Addendum No. 2
Solicitation 25-99328
Junction Avenue and St. Marie Street Reconditioning

NOTICE

JUNCTION AVE/ST. MARIE ST. RECONDITIONING

1	03/25/2025	ADDENDUM 01
DUCT BANK ALIGNMENT		
SHEET NO. DB01 OF DB14 SHEETS

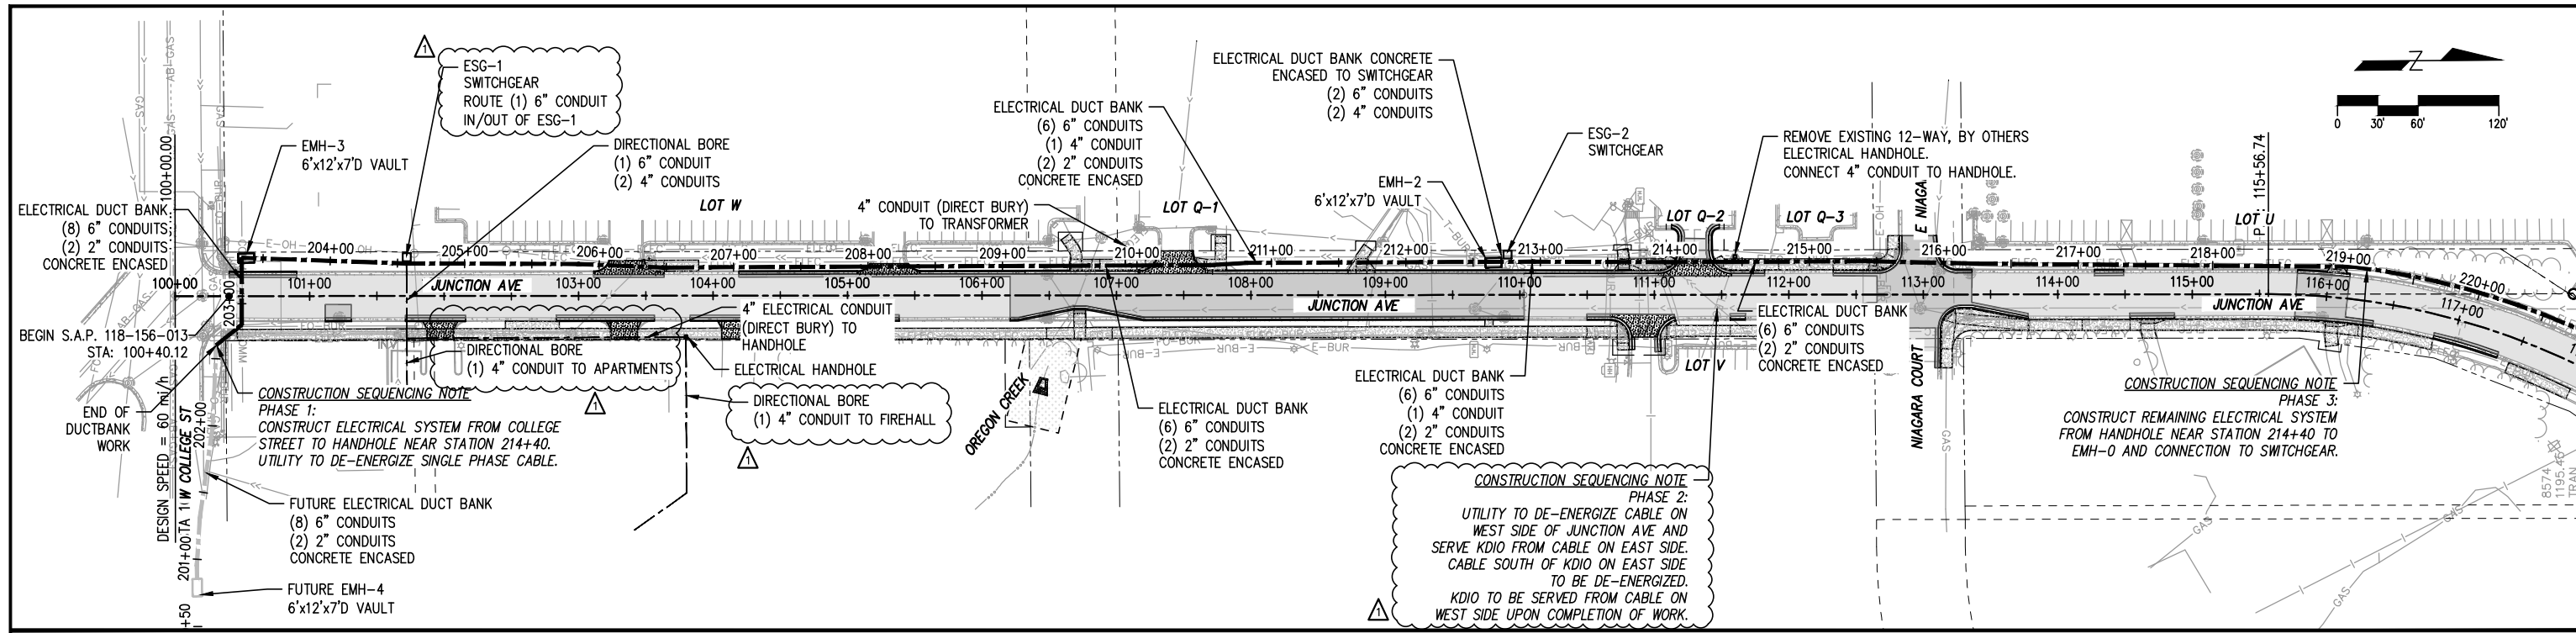
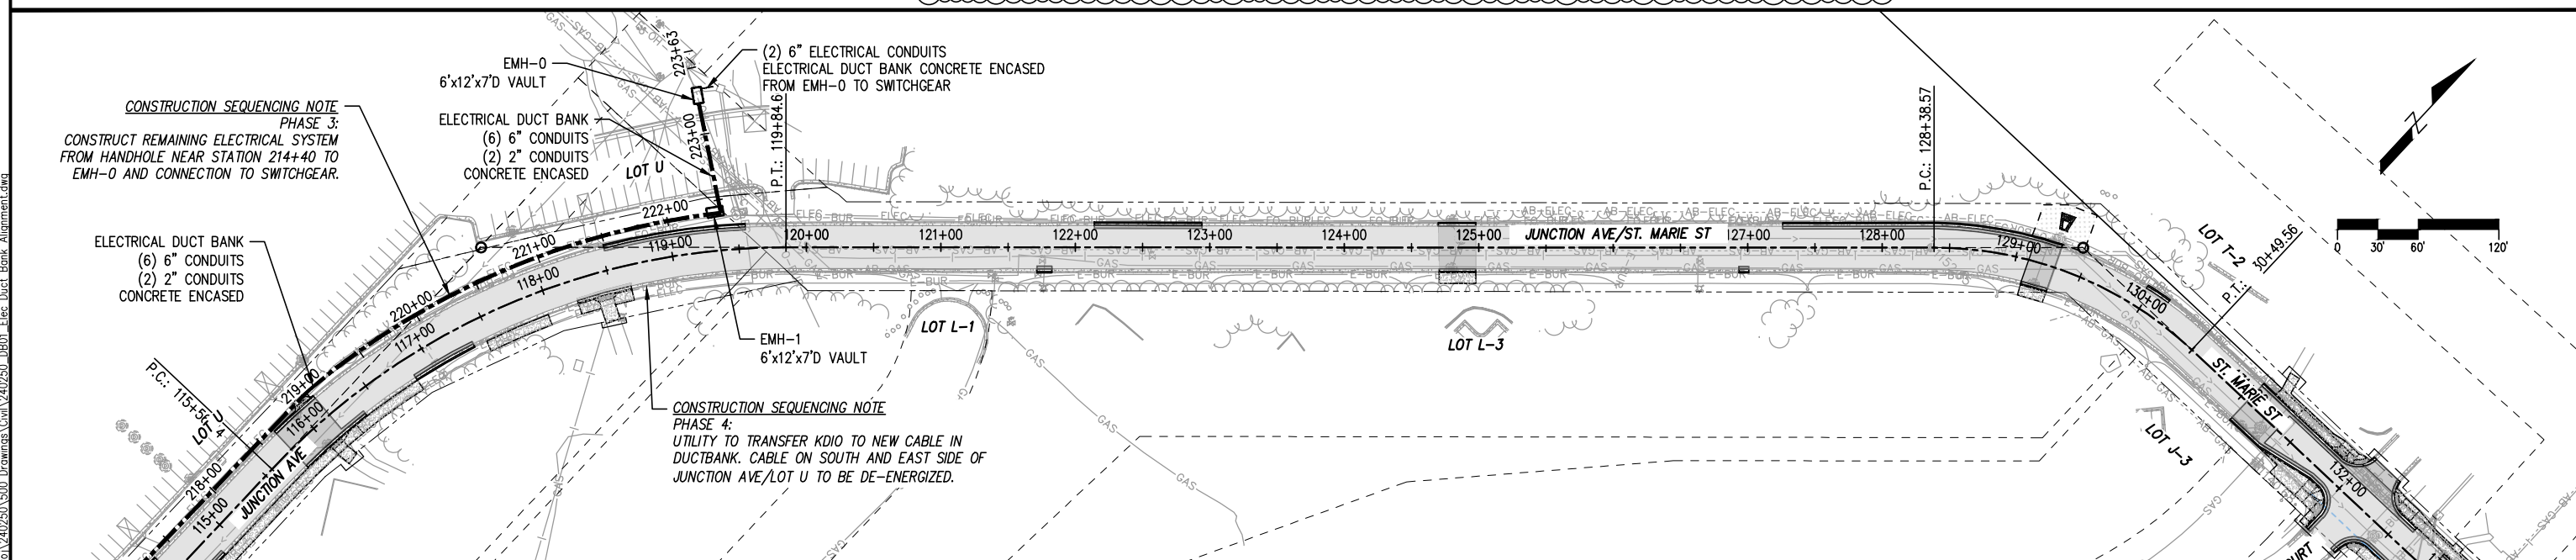
- i. Updated structure number PCB-208 RIM elevation to 1130.17.
8. Drawing changes to the DUCT BANK are as follows:
 - a. Sheet DB01; Delete Sheet DB01 in its entirety and replace with revised Sheet DB01.
Revisions to Sheet DB01 are as follows:

- i. Amended note "ESG-1 SWITCHGEAR" to include "ROUTE (1) 6" CONDUIT IN/OUT OF ESG-1

- ii. Amended note 3 “The final duct bank alignment is expected to change from the plan alignment based upon field conditions, utility conflicts and the need to minimize curb and gutter removals.”

- iii. Added items:
 - 1. DIRECTIONAL BORE (1) 4” CONDUIT TO APARTMENTS
 - 2. DIRECTIONAL BORE (1) 4” CONDUIT TO FIREHALL
 - iv. Revised construction sequencing note

SHEET NO. DB02 OF DB14 SHEETS

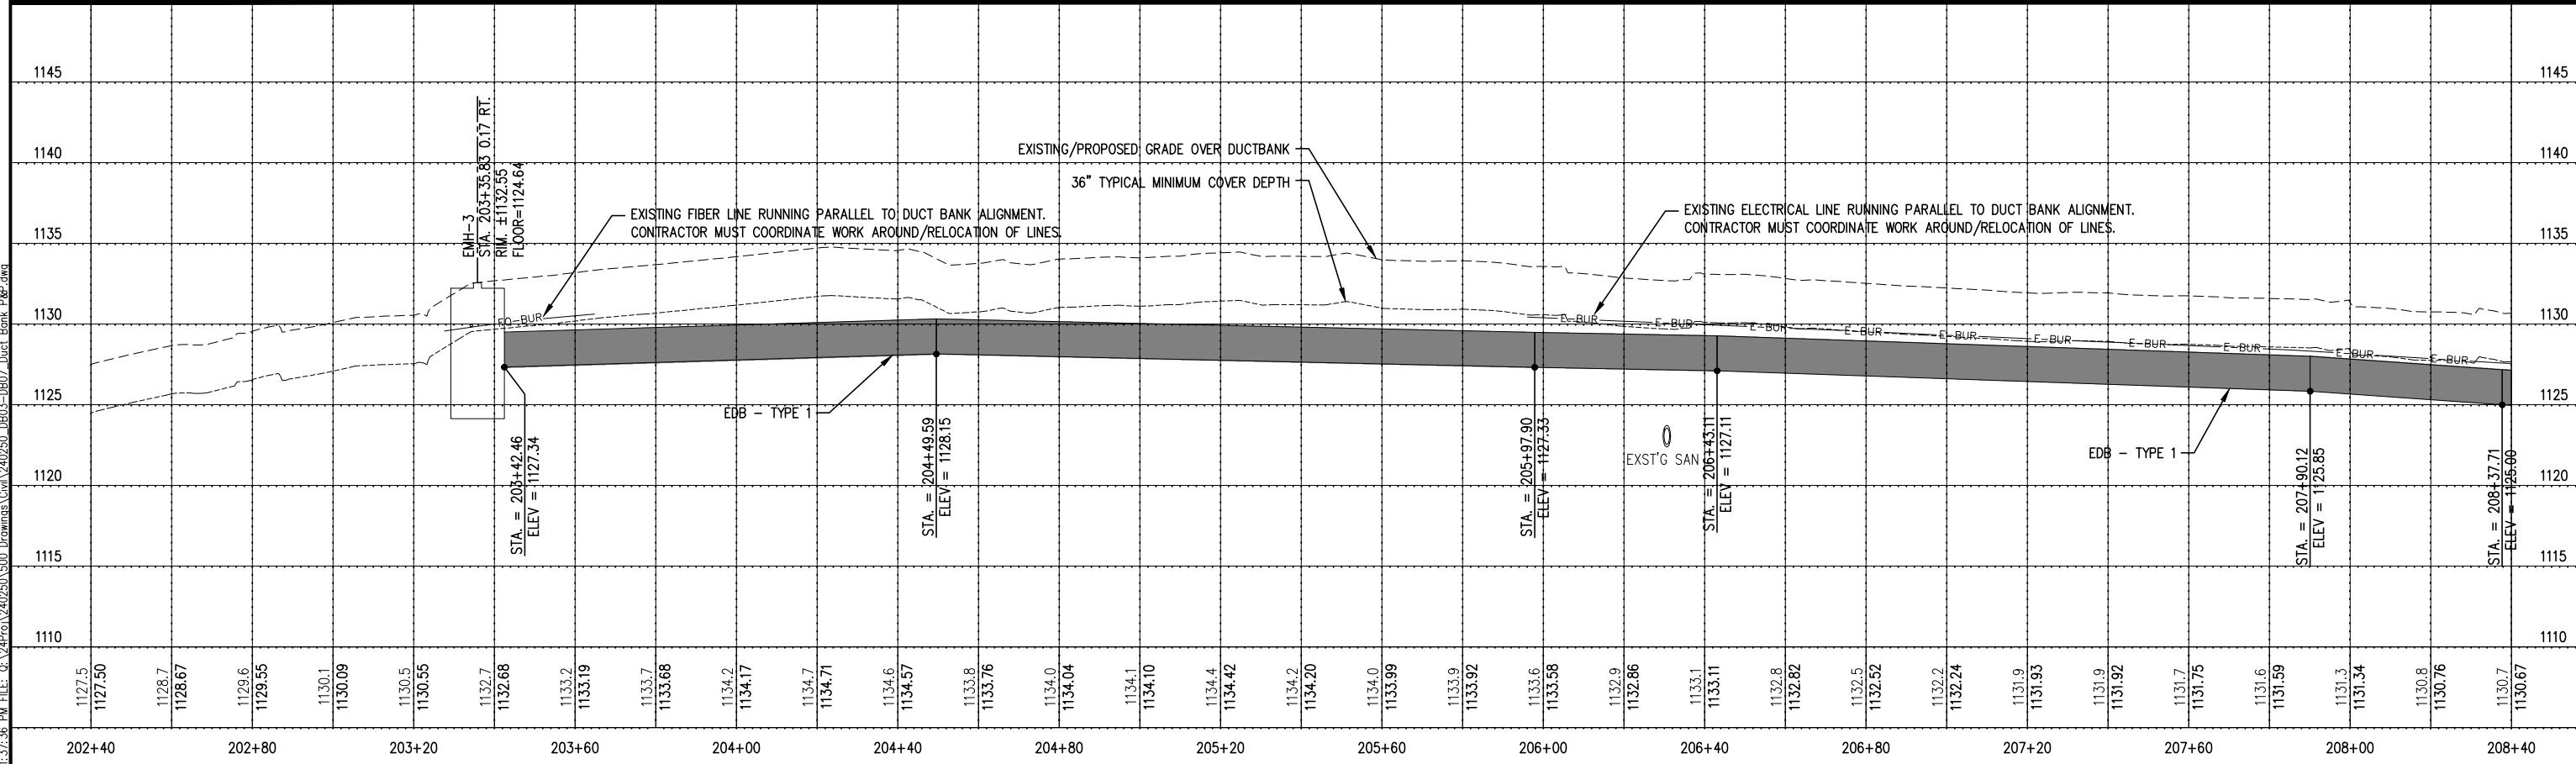
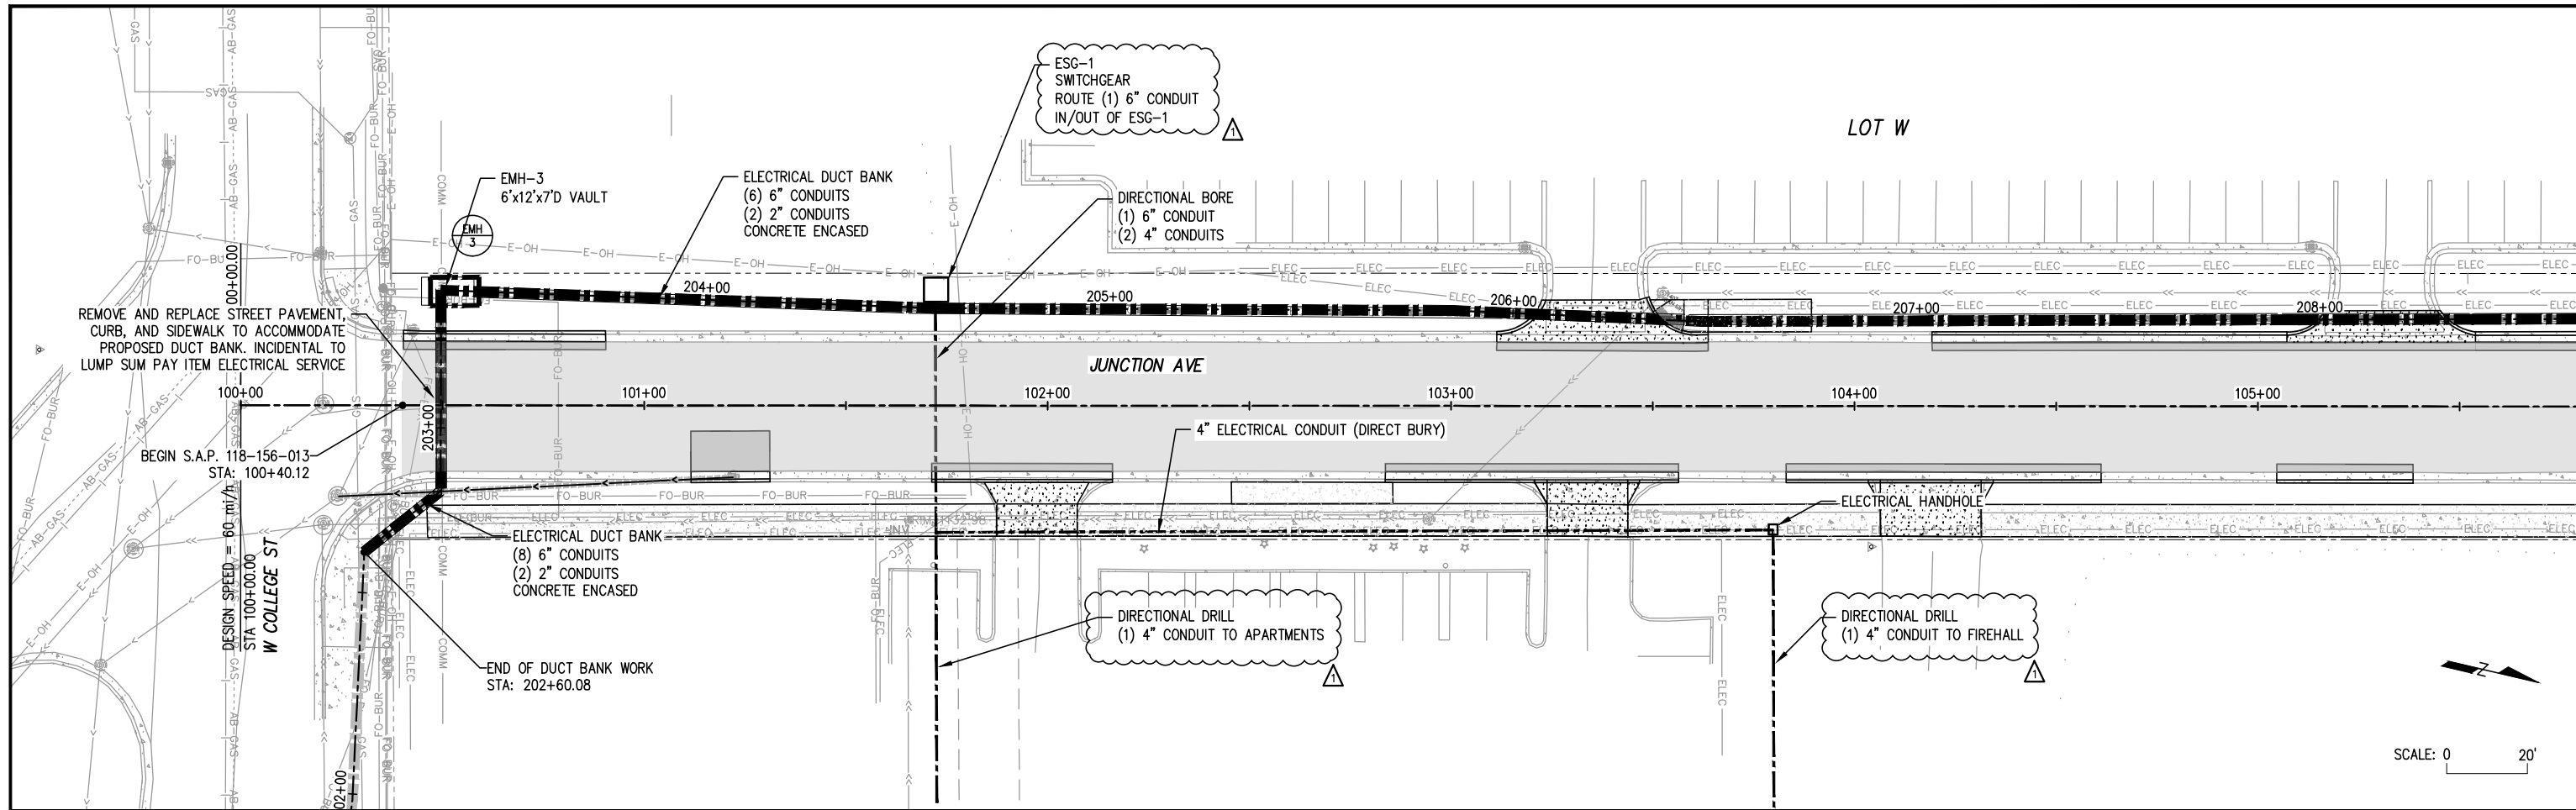
- b. Sheet DB02; Delete Sheet DB02 in its entirety and replace with revised Sheet DB02.
Revisions to Sheet DB02 are as follows:
 - i. Increased ()” NON-METALLIC CONDUIT ELECTRICAL DUCT (DIRECTIONAL BORE) 2550 to be 256 LF
